# Editorial simplification of the RTS-without-squelch state diagram

(addressing comment #R2-114)

# Figure 178B-15 in D3.2

Figure 178B-15—RTS without squelch state diagram

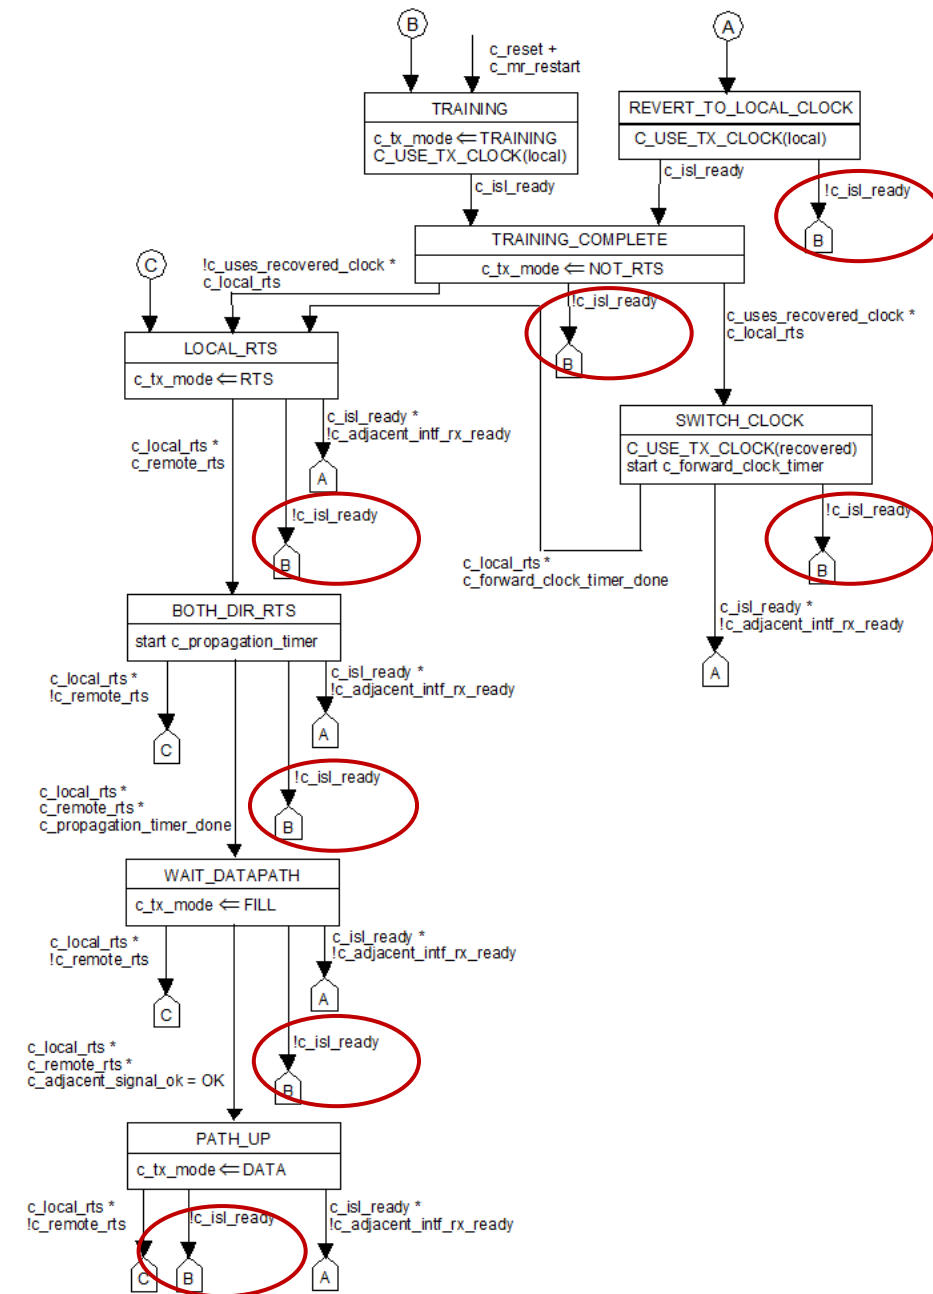
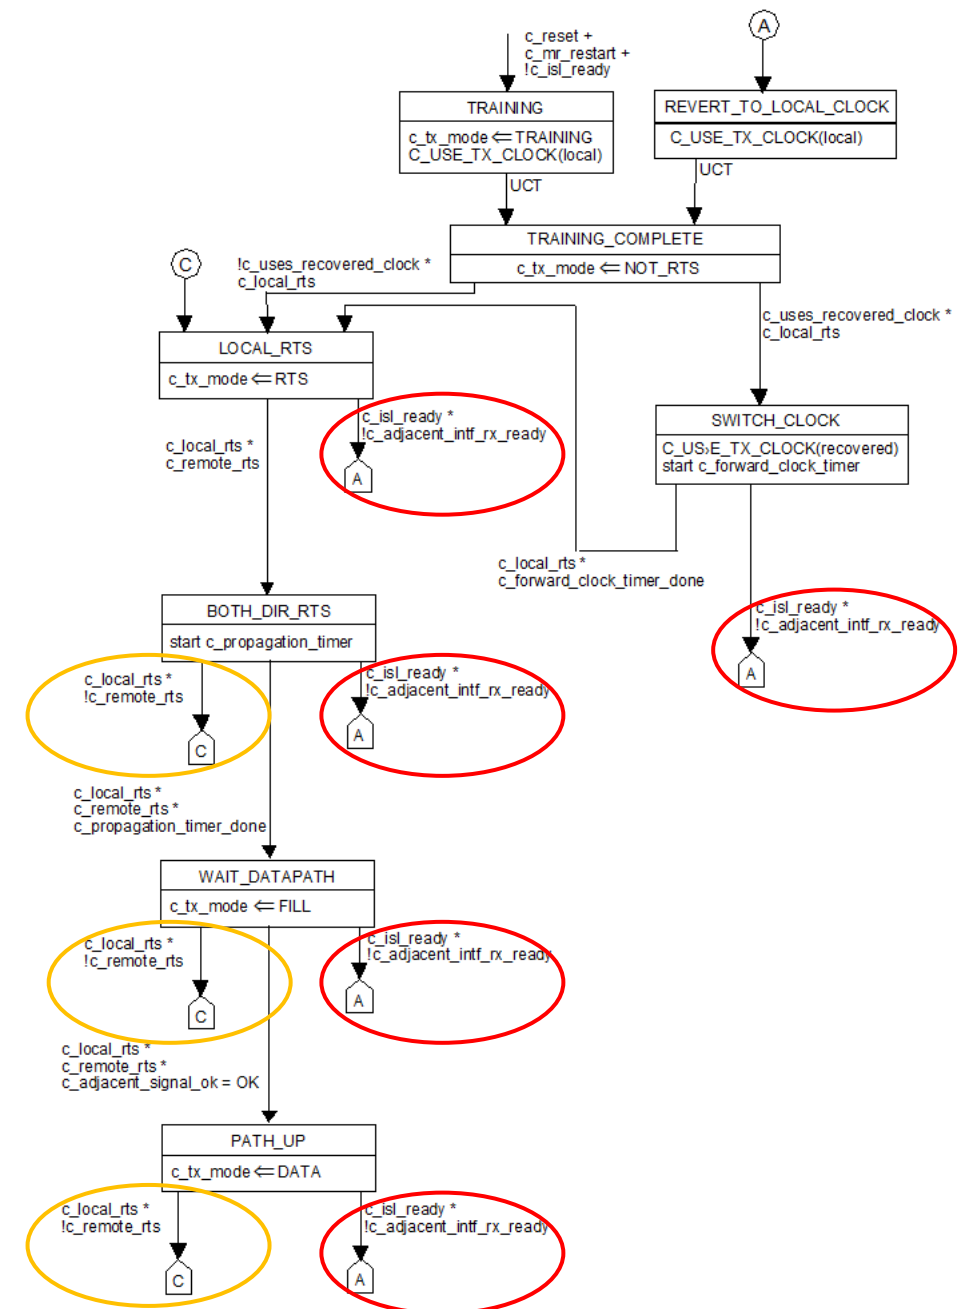
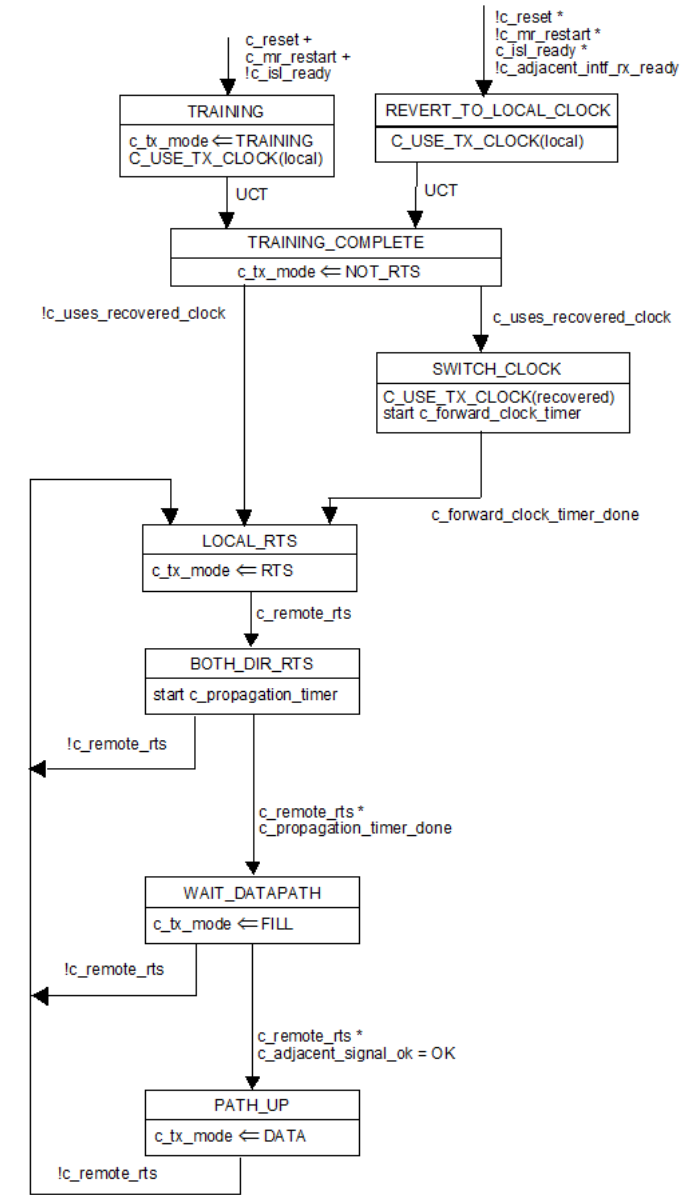
- All states except the initial TRAINING have transitions into TRAINING (“B”) with the same condition: “!c\_isl\_ready”
- This means !c\_isl\_ready is a “reset-like” condition
- All these transitions can be represented by adding the condition to the open arrow into TRAINING, as shown in the next slide.

- Multiple transitions to REVERT\_TO\_LOCAL\_CLOCK (A) with the same condition (but with lower precedence than those to TRAINING)
- $c\_local\_rts$  is a condition on all other transitions
  - $= c\_isl\_ready * c\_adjacent\_intf\_rx\_ready$
  - If it is false, one of the two terms must be false, which will cause a transition:
    - $\neg c\_isl\_ready \rightarrow \text{TRAINING}$
    - $\neg c\_adjacent\_intf\_rx\_ready \rightarrow \text{"A"} (\text{REVERT\_TO\_LOCAL\_CLOCK})$
  - Therefore  $c\_local\_rts$  is a redundant term
- 3 transitions to LOCAL\_RTS (C) use the same condition  $c\_local\_rts * \neg c\_remote\_rts$
- $\Rightarrow$  The figure can be simplified further

- This diagram is logically equivalent to the current one.
- The simplified structures enables better understanding of the requirements and the expected behavior.
- Using this diagram is proposed to address comment #114.
- Any changes resulting from other comments can be applied in addition.
